U.S. Department  
of Transportation  
**Federal Highway  
Administration**

September 11, 2007

In Reply Refer To: HSSD/B-162

In his letter of May 7, 2007, Mr. Dallas James of Armorflex Ltd requested formal Federal Highway Administration (FHWA) acceptance of a new steel strong post (called the Nucor Steel Post) for use in a new 31" (787 mm) high Nucor Strong Post W-beam guardrail system with no blockouts in both roadside and median applications. He also requested formal FHWA acceptance of the Nucor Steel Posts as a substitute for other approved posts in the standard 27" (686 mm) high non-proprietary strong post W-beam guardrail systems with the use of an original plastic blockout. This request was limited to roadside applications only. To support his request, Mr. James also provided a copy of a Holmes Solutions Limited test report dated March 2007, entitled "31 Inch Nucor Strong Post W-Beam Guardrail without Blockouts" and a copy of a Holmes Solutions Limited test report dated March 2007, entitled "27 Inch Nucor Strong Post W-Beam Guardrail with Plastic Blockouts." Mr. James also provided copies of the drawings, test videos, photos, raw data and analysis files and a copy of the co

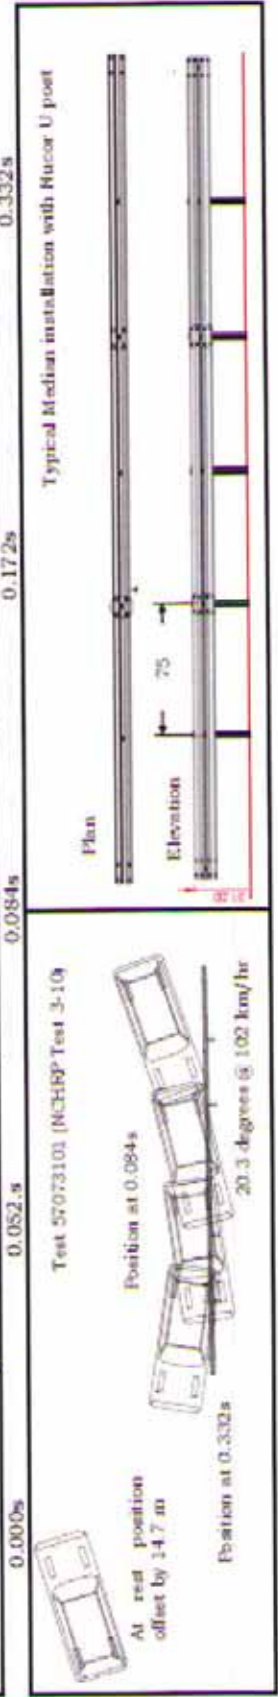
According to the information you provided the test article performed successfully in the above tests. The system redirected impacting vehicles which did not penetrate, underride, or override the installations and remained upright during and after the collision period. There was only minor deformation of the occupant compartment. Occupant risk factors were within the limits specified in the NCHRP 350. Summaries of tests results are presented in Enclosure 2.

In the conducted tests no detached elements, fragments, or other debris showed potential for penetrating the occupant compartment, nor to present an undue hazard to other traffic. However, in test 3-10 one post was broken off at ground level with a large segment of the post coming to rest 6 m behind the barrier approximately 17 m downstream from the point of impact. Test videos show that the broken off part of the post was sliding at ground level before coming to rest and therefore the hazard to other traffic in median application on a level surrounding surface would be minimal. However, the described tendency of the posts to break off should be recognized and should be taken into account when selecting locations for installations. Also, this tendency may be more pronounced when the system is used in the frozen ground or when the surface is paved.

In summary we agree that Nucor Strong Post W-beam guardrail system without blockouts in both roadside and median applications as described above meet the appropriate evaluation criteria for the NCHRP 350 TL-3 devices. Also, the Nucor Strong Posts as described above can be used as a substitute for other approved W-beam posts in the standard 27" (686 mm) high non-proprietary strong post TL-3 W-beam systems with the use of plastic blockouts in the roadside configuration. They should not, however, be used as one-for-one replacements of W6 x 8.5 steel posts in repair/maintenance situations until further testing is conducted.

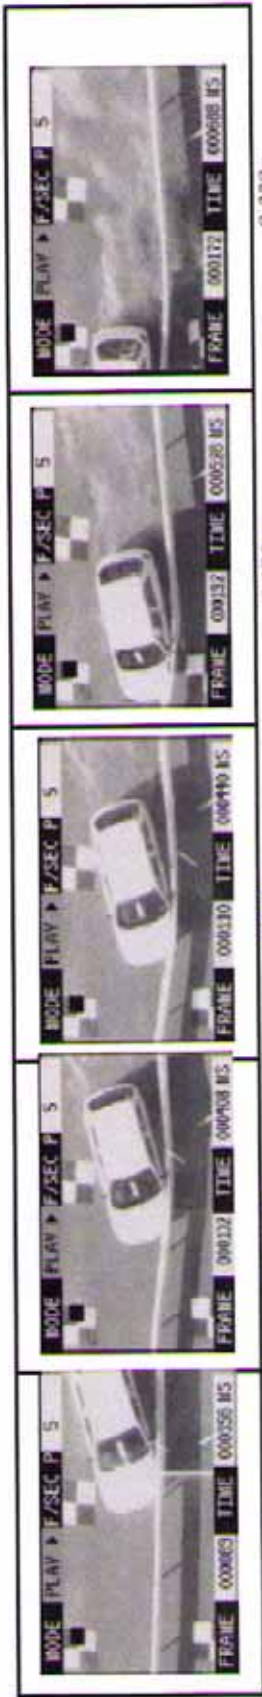
Similarly, I agree that Test 3-11 which uses a 2000P truck impacting the 27" (686 mm) high W-beam guardrail system in the roadside configuration is sufficient to evaluate the performance of this system. Conducting Test 3-10 would be redundant as the system is similar to the previously approved non-proprietary W-beam systems and is unlikely to cause any concerns in impacts with a small car.
